Rezoning Transportation Analysis
Petition Number: Insert Zoning Petition #2021-214
General Location Identifier: 11123345

Revision Log:

Date	Description
01-21-2022	First Review (AO)
02-24-2022	Second Review (AO)

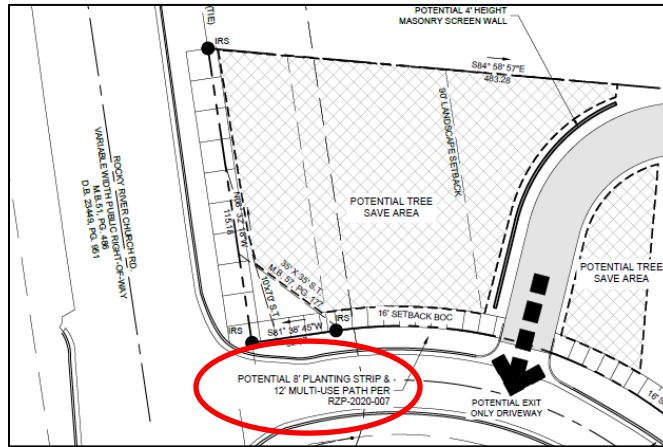
1. ~~**Curblines:** The proposed zoning district has a setback measured from back of the existing or proposed future curblines.~~
 - a. ~~**Rocky River Road:** Location of curb and gutter is in its existing location.~~
 - b. ~~**Woodland Beaver Road:** Location of curb and gutter is in its existing location.~~

Label and dimension the curb and gutter from the centerline for each road on the site plan.

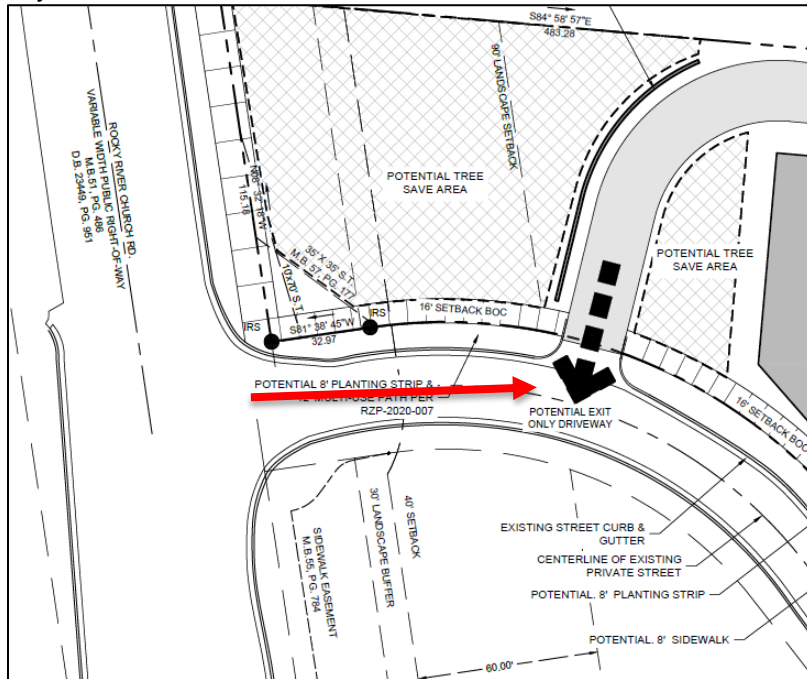
3. ~~**Resolved (New Site Plan, 2-14-22):** Revise site plan to commit to construct an 8-foot planting strip, 12-foot multi-use path along Rocky River Road and an 8-foot planting strip and 8-foot sidewalk on Woodland Beaver Road. Site plan shows call out show multi-use path along Woodland Beaver Road.~~

The site plan shall label and dimension both items from the back of curb and gutter and road centerline.
